Your ref: TR010022  
Our ref: ADL/RG/ls/2680

24 June 2020

**Re: McDONALD'S, MARKEATON PARK**

Following from the Hearing of 9<sup>th</sup> June 2020 there was an online meeting on 16<sup>th</sup> June between the representatives of McDonald's and Euro Garages with Aecom/Derby City Council as highway authority and the matters discussed were:

Drawing No. 4200226-1000 Rev P1

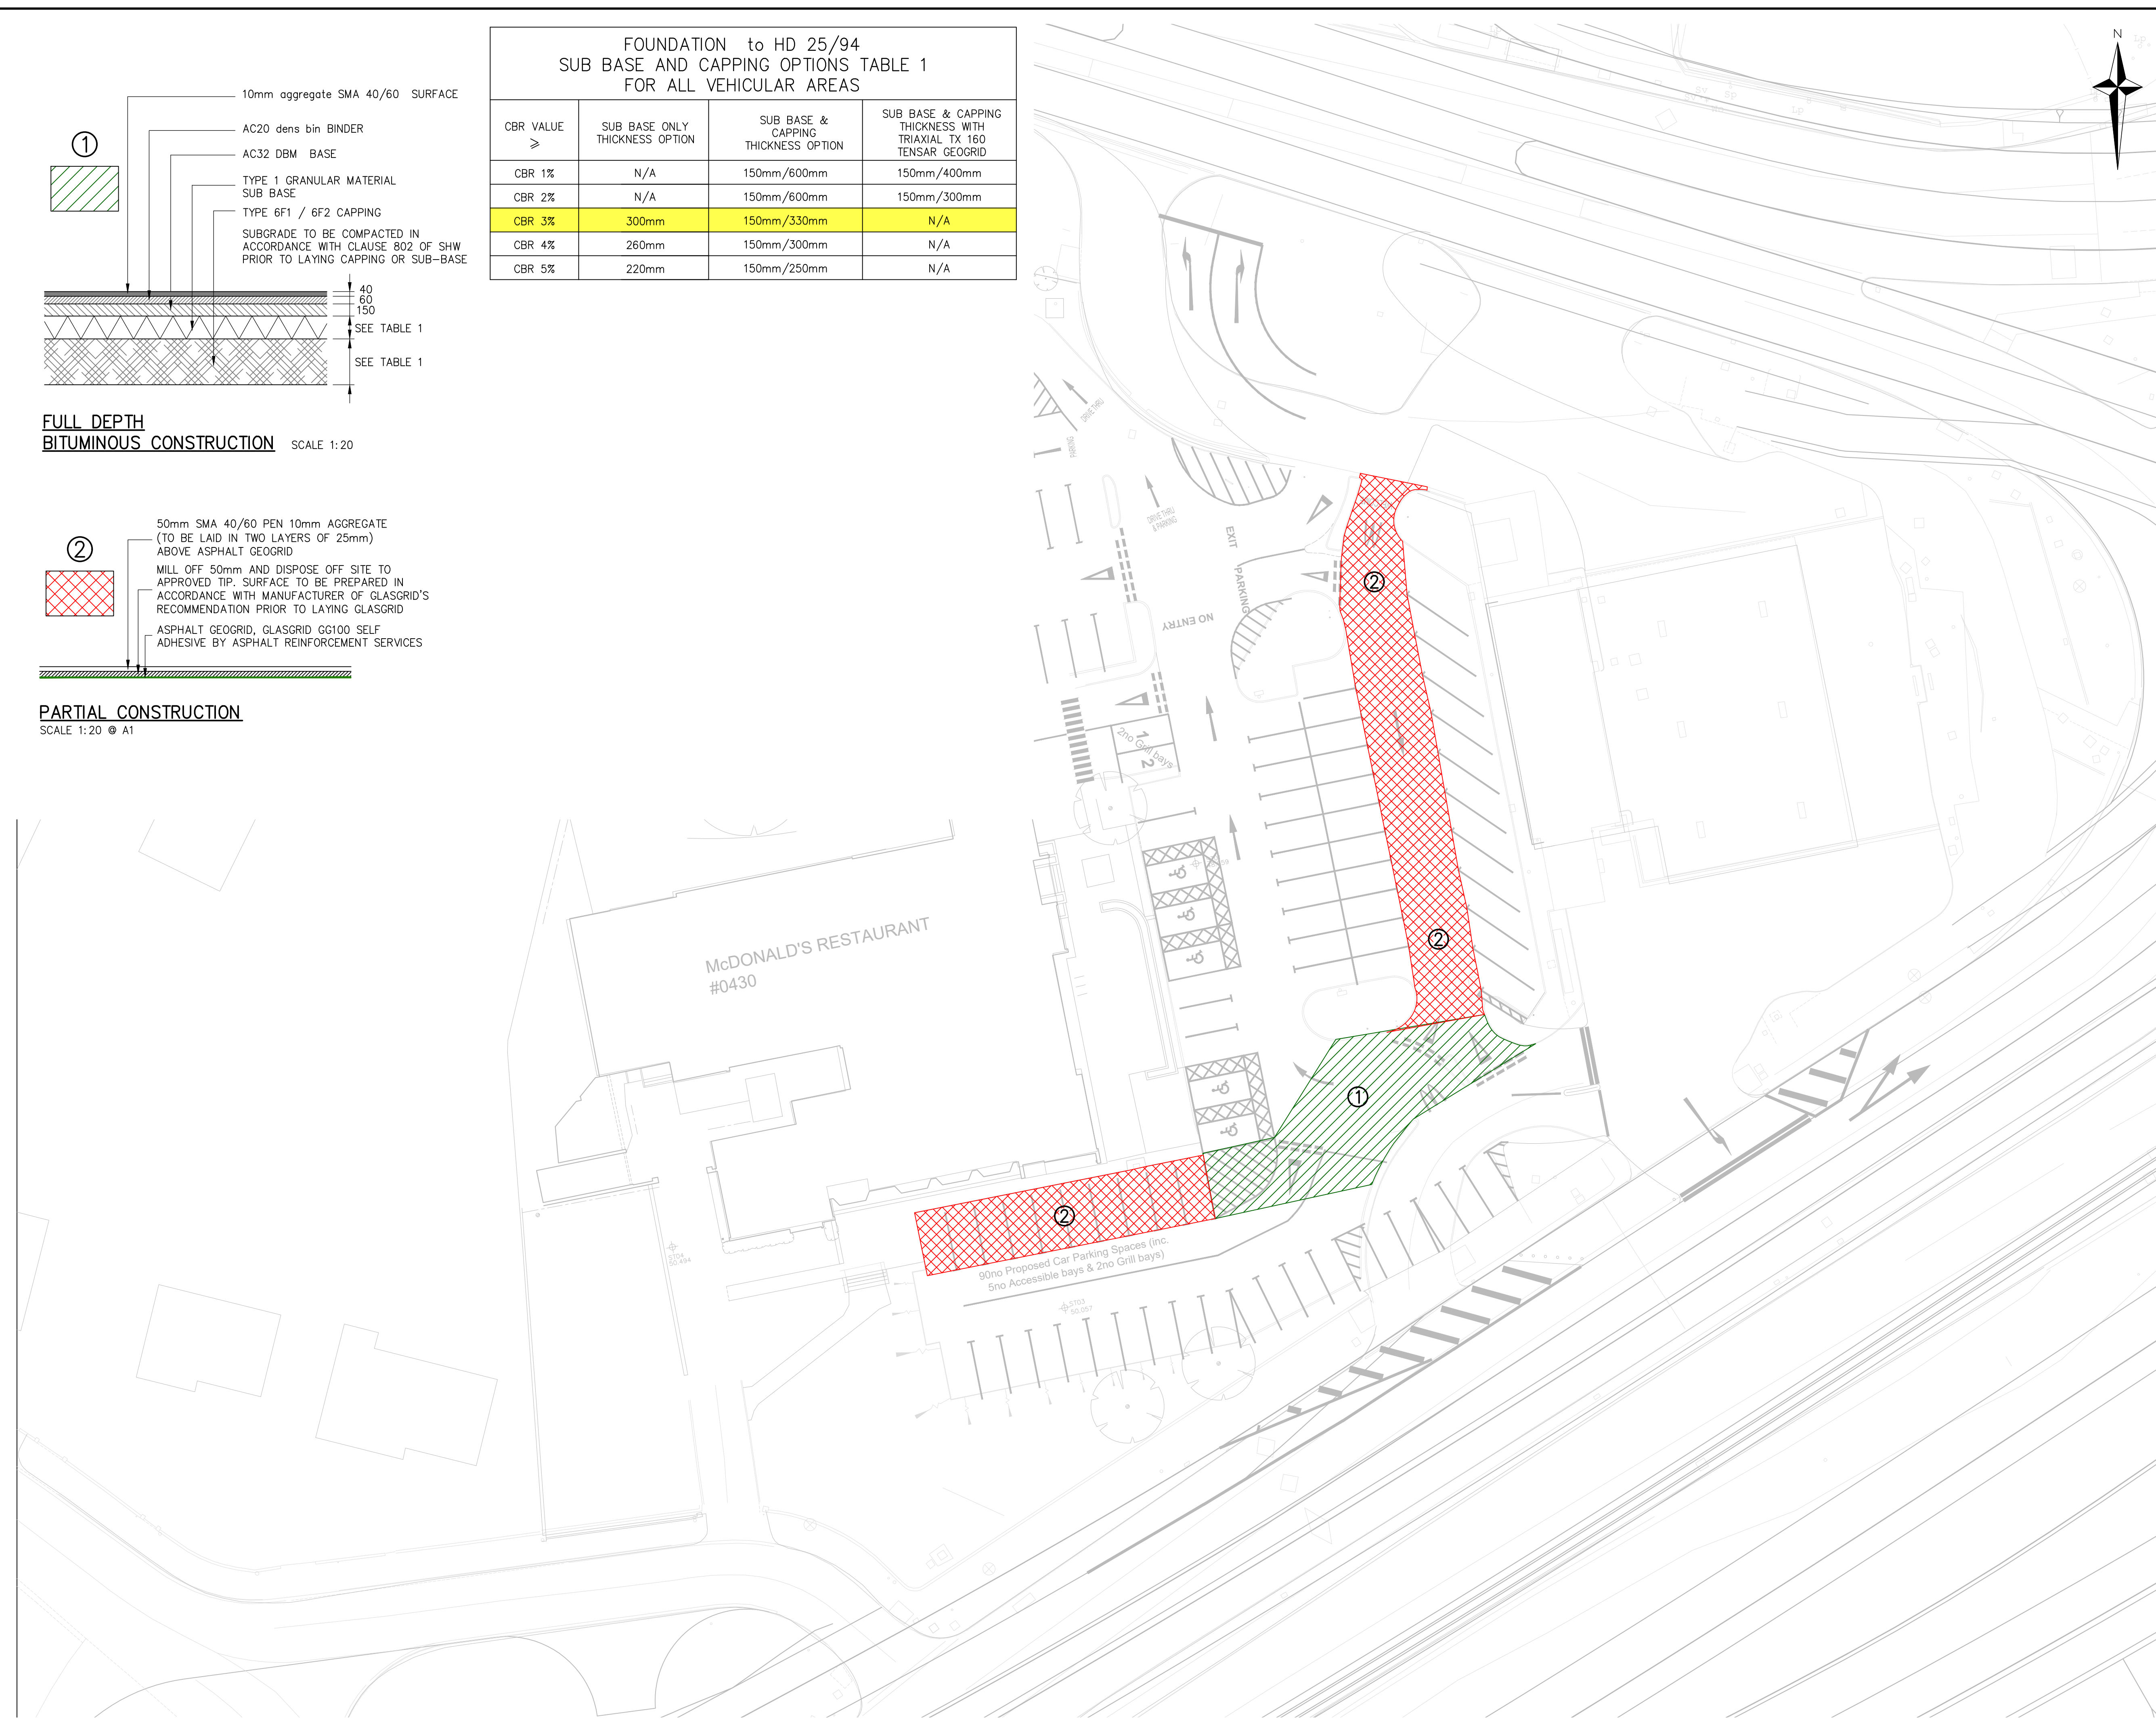
Please find enclosed a conditions report undertaken by ST Consult, on behalf of our Client and drawing 4200226-1000 P2 (Proposed Finishes) by Glanville Consultants. The work shows that currently the areas of the car park used now, and potentially in the future are both in need of improvement.

The red area shown on drawing 4200226-1000 P2 shows the existing areas of delivery manoeuvres and therefore would fall under McDonald's own programme of maintenance and repairs to the store. The green area has until now, never been used for HGV access and therefore it is prudent to ensure the longevity of this through thorough improvements to reduce our Clients exposure to future maintenance and repair costs as a result of the changes in operation needed to accommodate HE's proposals.

Our Client will be seeking financial compensation for these works, so that their own contractor team with experience of working in and around an operational McDonald's restaurant can undertake the works on a programme designed to fit in around restaurant activity, in order to minimise interruption to the business.
